Hi-Fi Products Service Bulletin

Model: GEN-HFP

No. 428

Subject: A Whistling noise is heard when playing certain

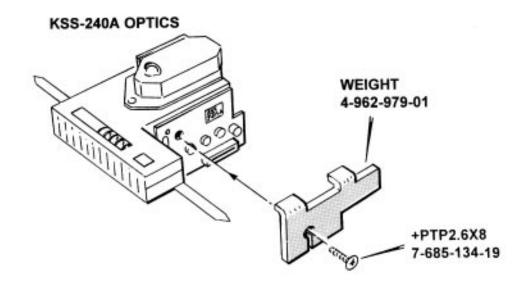
A whistling noise can be heard from the mechanical assembly. The whistling noise is a result of vibration of the disc, optical lens, and BU base which results in an audible resonant frequency. The following modification is applicable to all units that use the KSS-240A optics and exhibit the audible noise.

To reduce the vibration of the BU base add the weight (P/N 4-962-979-01) to the optical block using a +PTP2.6X8 screw (P/N 7-685-134-19) in place of the original screw.
